COUNCIL BRIEFING REPORT

Panel Reference	PPSSEC-214
DA Number	DA 2022/16
LGA	Burwood
Proposed Development	Alterations and additions to Strathfield Private hospital for the demolition of the existing dwelling at 47A Wentworth Road, tree removal and the construction of a 3 storey building containing basement and ground level parking, 13 additional beds, 2 operating theatres and ancillary services
Street Address	47A Wentworth Road & 3-5 Everton Road, Strathfield NSW 2135
Applicant/Owner	Mr K Mayoh – Ramsay Health Care Australia Pty Limited
Date of DA lodgement	15 March 2022
Number of Submissions	Two (2) – at the time of Briefing Report preparation
Regional Development Criteria (Schedule 7 of the SEPP (State and Regional Development) 2011	Proposed cost of development \$19,959,000.00
Report prepared by	Emma Buttress-Grove, Senior Town Planner & Business Improvement Officer – City Development
Report date	2 September 2022

Figure 3: Proposed basement level alterations and additions. Source: HPI

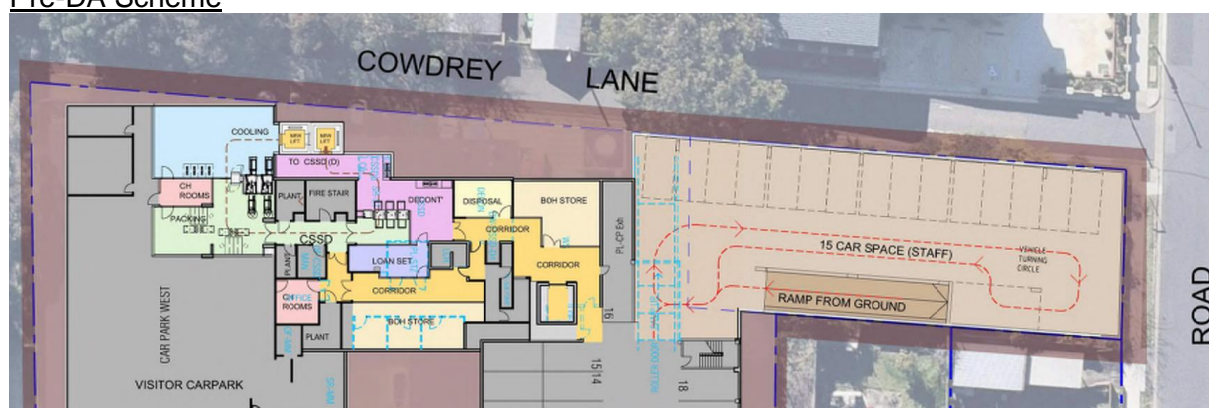
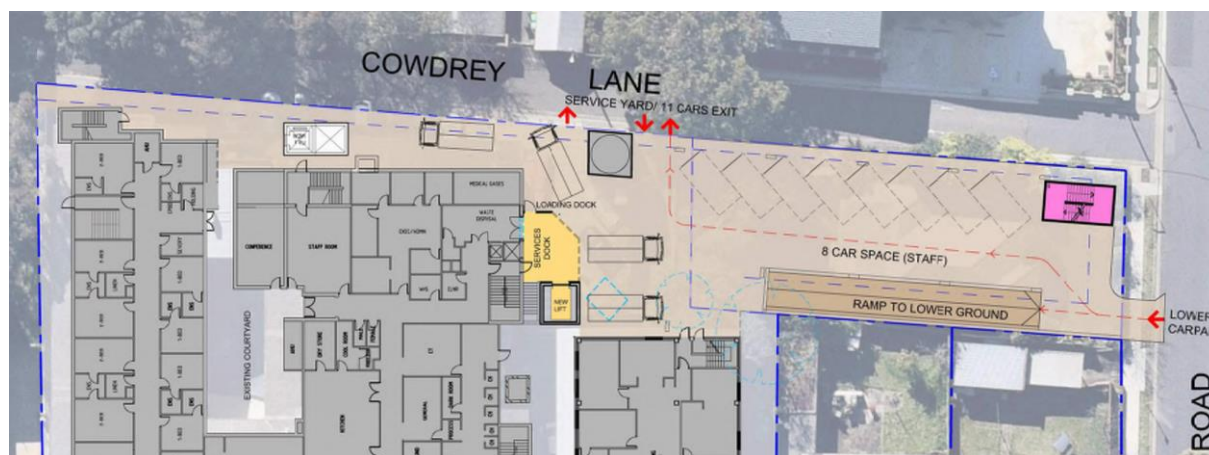
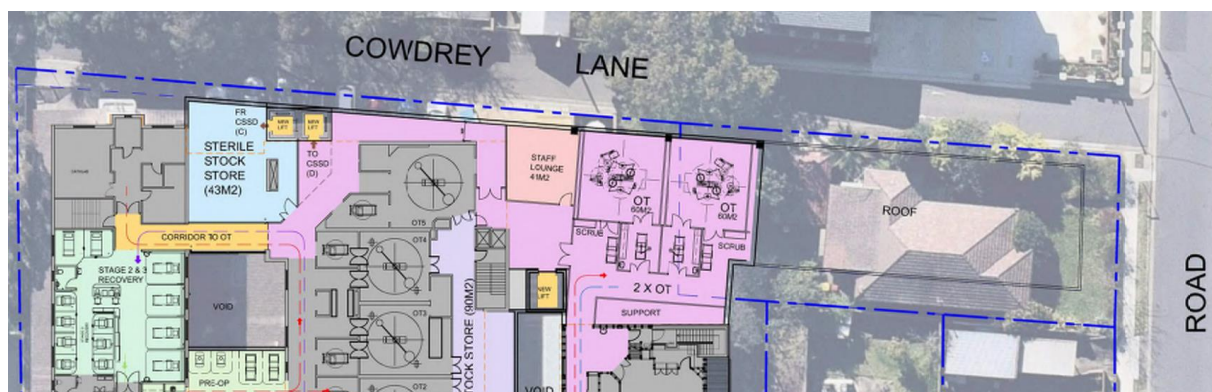
Following an assessment of the Pre-DA, written advice was provided to the applicant raising the following matters that required attention for any future development application lodged with Council.

- Increase the setback of the development to Wentworth Road
- Consider increasing setback of the development along Cowdery Lane
- Potential privacy impacts to No's 1 & 1A Everton Road created by the open stairs on the southern elevation
- Potential shadow impacts of the building upon the POS areas of No. 1 & 1A Everton Road needs to be considered and satisfactorily addressed
- Further consideration of landscape treatment along the southern boundary adjacent to No's 1 & 1A Everton Road.
- Potential for acoustic impacts upon No. 1 & 1A Everton Road created by the vehicular driveway entrance along the southern boundary.
- Visual impacts of the at grade car open parking area and its presentation to Cowdery Lane and Wentworth Road, further treatment is required.

- Council would encourage the applicant to ensure sympathetic colours, materials and finishes be applied to the Wentworth Road and Cowdery Lane facades. Face brick, rendered brick or similar is preferred with landscaping. Council would not encourage large concrete facades.

- The materiality of brick face is encouraged, this assists the proposed development to blend within the setting, as does the proposed masonry fence and garden setting on the NE corner of the site, nearest the heritage item.

- Concerns are raised with the open carpark area on the ground floor and how this will impact views to and from the heritage item, noting the concept plan shows narrow screen planting. For DA lodgement, Council would like to see examples of this used successfully elsewhere or alternative sympathetic screening options. A further setback between the development and the original section of the heritage item (in particular) would be a better option.

- There are other opportunities to make this more sympathetic, that being the increased setback from Cowdery Lane and/or improved landscaping/screening of the ground floor carpark.

- As there are no specific parking rates in Council's DCP for the proposed use, a Transport, Traffic and Parking Impact Report and Management Plan shall be submitted in any formal DA submission.
- A service vehicle/s is currently required to reverse into the site from Cowdery Lane. Whilst this is probably the way deliveries are undertaken at the moment the proposal should seek to improve upon the existing situation and ensure service vehicles can enter and exit the site in a forward direction.
- There is an existing structure on the sites northern boundary which looks to be retained in the plans which will restrict sightlines for drivers attempting to reverse into the site. Further investigation into how service vehicles can enter and exit the site in a forward direction should be explored.

- No objection to the tree removal and existing vegetation from Council's Tree Management Officer
- Due to the basement car parking level below the soil depth of the landscaped area within the front setback should be of a sufficient depth to support the proposed planting scheme.
- All proposed species of trees, shrubs and perennials must be nominated and clearly indicated on the Landscape Plan. A plant schedule must be included on the Landscape Plan showing species names, potential heights and spreads, quantities, and container sizes. Landscaping must relate to building scale.

Figure 8: DA proposed ground level alterations and additions. Source: HPI

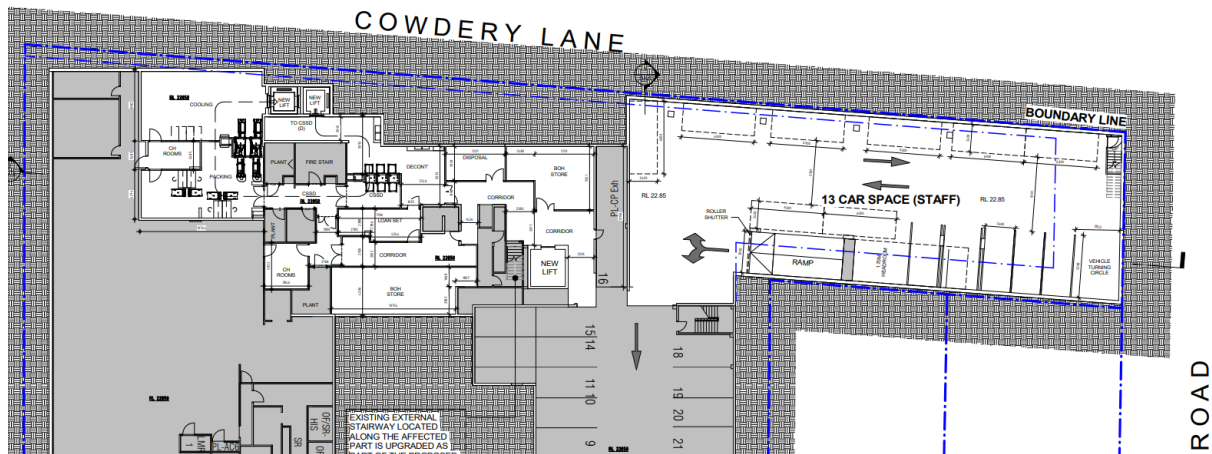
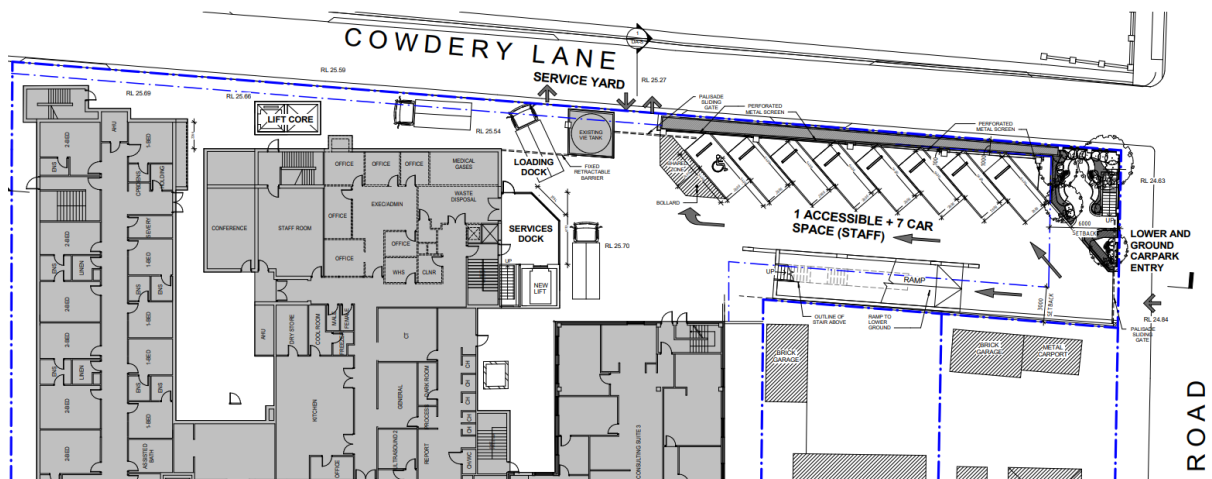
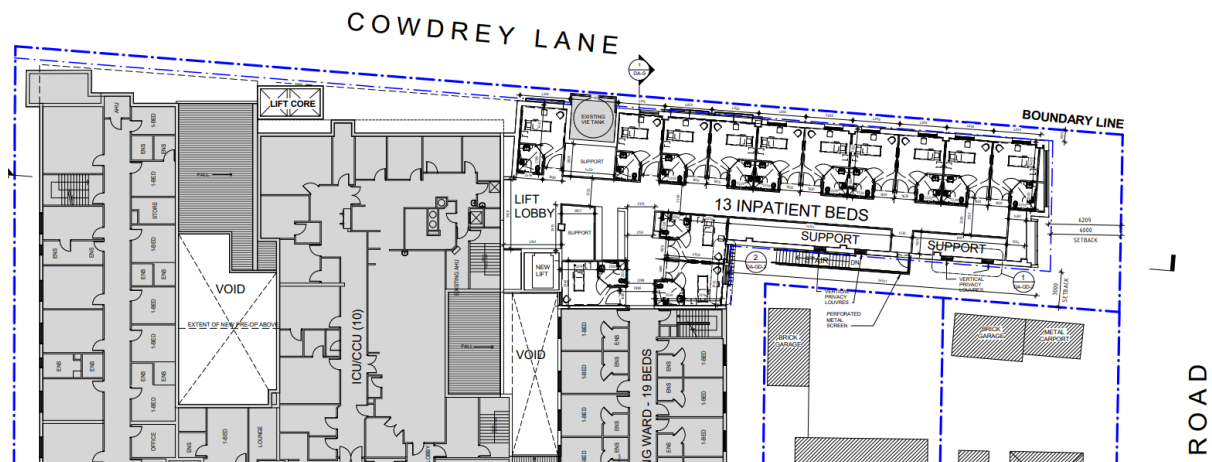
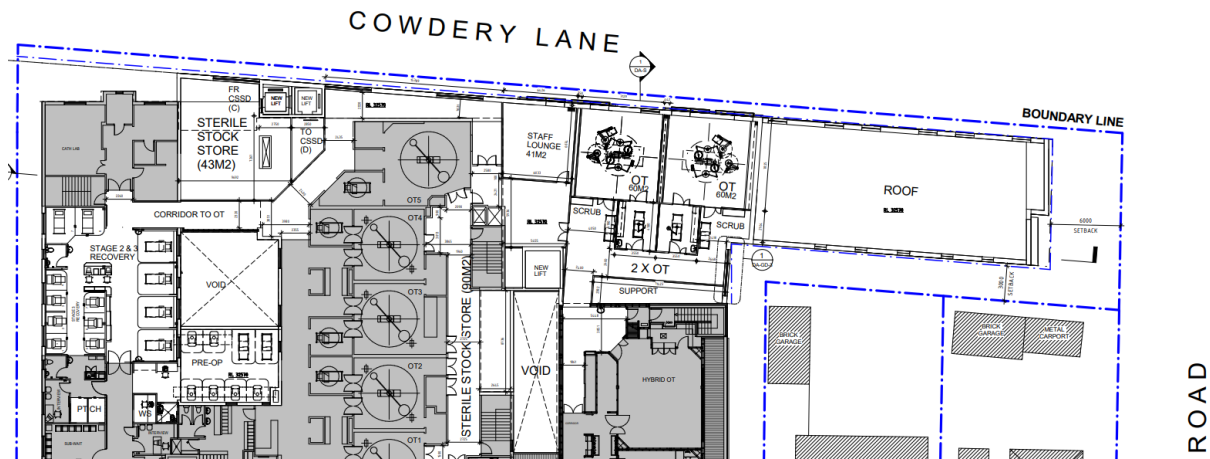
The DA scheme proposes a 1m setback from Cowdery Lane at both ground and first floor level. Whilst it is noted that the Landscape Scheme proposes landscaping (Lilly Pilli's) along this boundary which may assist in screening at ground level, the first floor wall has a length of approximately 45m without any meaningful articulation provided to the wall with exception to a screening device which protrudes into the 1m setback.

It has previously been raised by Council that the ideal proposition for redevelopment of No. 47A Wentworth Road to be incorporated into the hospital site would also include the properties at No. 1 & No.1A Everton Road as this would enable a more flexible design approach, and the opportunity to provide additional setbacks to boundaries, a more articulated built form/building envelope and increased landscaped area and planting.

The applicant has advised these properties are unable to be included in the proposed development, and whilst it is recognised that the resultant design and positioning of the built form on the site will be somewhat constrained by the existing frontage width of No. 47A Wentworth Road, it is considered that the development can be designed so as to present a built form to Cowdery Lane at first floor level that is appropriately articulated and provides some visual building break and relief.

Please note that no expansive wall lengths in the absence of any articulation will be supported, and no encroachments of any new building component shall be less than 1m from the boundary to Cowdery Lane at first floor level.

The at-grade car park level is required to be screened by a fixed structure. The structure is to be installed between the car parking support columns and not in front of the building. This screening shall be a material and finish that is appropriate to the overall design of the building,

and shall be installed along the Cowdery Lane frontage of the carpark, and the carpark return wall facing Wentworth Road.

This fixed screening is in addition to and does not replace the requirement for landscape screening as proposed in the Landscape Concept Plans.

Please provide shadow diagrams in plan and elevation prepared in hourly intervals between the time stations of 9am-3pm on June 21 (winter solstice) indicating the solar access impacts as a result of the proposed new building and the timber acoustic wall along the southern boundary upon the northern external walls (including all windows and door openings) and the POS areas of the dwellings at No. 1 & No. 1A Everton Road, Strathfield to the south of the subject site.

The windows in the southern external wall servicing the “support” areas of the first floor level that face the adjoining residential properties at No. 1 & No. 1A Everton Road shall either be highlight windows with the sill height no less than 1.6m above the finished floor level, or the windows shall be suitably treated for privacy, i.e. fixed louvre/angled screen externally to the window.

As raised as an issue in the objection submission – the development is proposing an “acoustic” wall to be constructed along the southern boundary of the site adjacent to the rear boundaries of No. 1 & No. 1A Everton Road, however there is no acoustic documentation provided in support of the acoustic wall and if it’s design and materials of construction will be suitable for it to function as its intended purpose.

- Ethelene Oxide Confirmation E-mail
- Updated Architectural Plans – including façade enhancements, modulations and breaks in the northern elevation of the building fronting Cowdery Lane
- Additional Solar Diagram Summary
- Updated Landscape Plans
- Noise Impact Assessment
- Structural Statement
- Updated Statement of Environmental Effects
- Updated Burwood Development Control Plan 2014 Compliance Table
- CPTED Report
- Remedial Action Plan

At the time of preparing this Briefing Report a preliminary assessment of the amended information has been undertaken, and the amended proposal is considered to have satisfied all of the matters listed in Council's RFI.
